Referrals Table

Internal Department/Officer	Referral Comments (Summarised)
Urban Design	<p>Comments provided on 12 May 2022</p> <p>Amended documents have been submitted which include the following urban design considerations:</p> <p><u>Canopy/awnings</u></p> <ul style="list-style-type: none"> Design developments have been made to ground floor canopies to refine their design for appearance and constructability. The proposed changes are considered appropriate. <p><u>Ground floor activation/transparency</u></p> <ul style="list-style-type: none"> Through block access along southern boundary is retained with clear, ramped laneway providing access to the office and bike storage entries. Integrated artworks previously proposed for the southern laneway and hotel porte cochere have been deleted. Office use has been retained and addresses the middle section of the laneway contributing to its activation and security. <p><u>Ground floor changes:</u></p> <p>The changes to the ground floor program will reduce the potential for internal activities to spill out and activate the abutting external spaces diminishing street level vitality. While this is not a desirable outcome it is considered accep

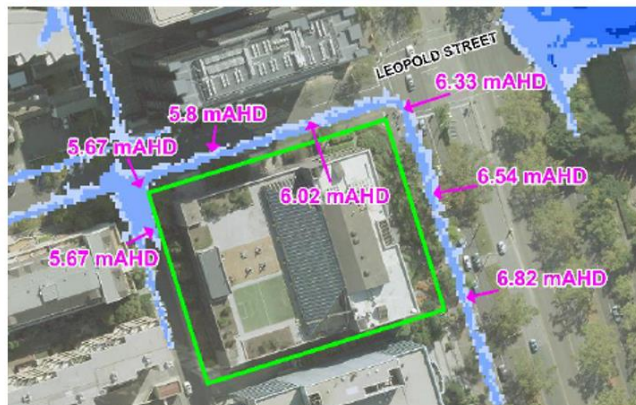
<p>Development Engineer</p>	<p>The designated flood level for the above property is 5.67m AHD. The SBO2 encroaches into the northwest corner of the property on the corner of Leopold Street and Queens Lane as shown below.</p> <p>The proposed works include construction of new multilevel building with underground car parks.</p> <p>The minimum required finished floor level for habitable area is 5.97m AHD (5.67m AHD + 300mm) and non-habitable area is 5.82m AHD (5.67m AHD +150mm).</p>

We are satisfied with the proposed impermeable wall at the corner of Leopold St and Queens Lane proposed to prevent the floodwater from the public realm entering the property.

- Could we please request applicant to have a notation on the drawings stating that the condition below (extracted from the Cardno Flood Impact Assessment) hasn't been undermined and there are measures in place to capture the water falling on parcel to prevent the water entering into the premises and prevent damage to assets that may be caused by this area being lower than the natural ground surface.

- > Water falling directly on the parcel (including onto the building itself and the excavated area surrounding it) will need to be appropriately collected and discharged from the site

- Access doors (Fire Booster , Substation) to the services as highlighted in yellow below, these doors are required to be:
 - Self-closing and can be held fully open against the building wall for the time personnel are occupying the facility;
 - In the fully open position do not encroach more than 100mm into the Road Reserve;
 - Have a minimum clearance of 150mm from the footpath surface;
 - Open onto a footpath with a minimum width of 1500mm.
 - The doors must be kept locked when not in use with the keys made available to approved personnel only
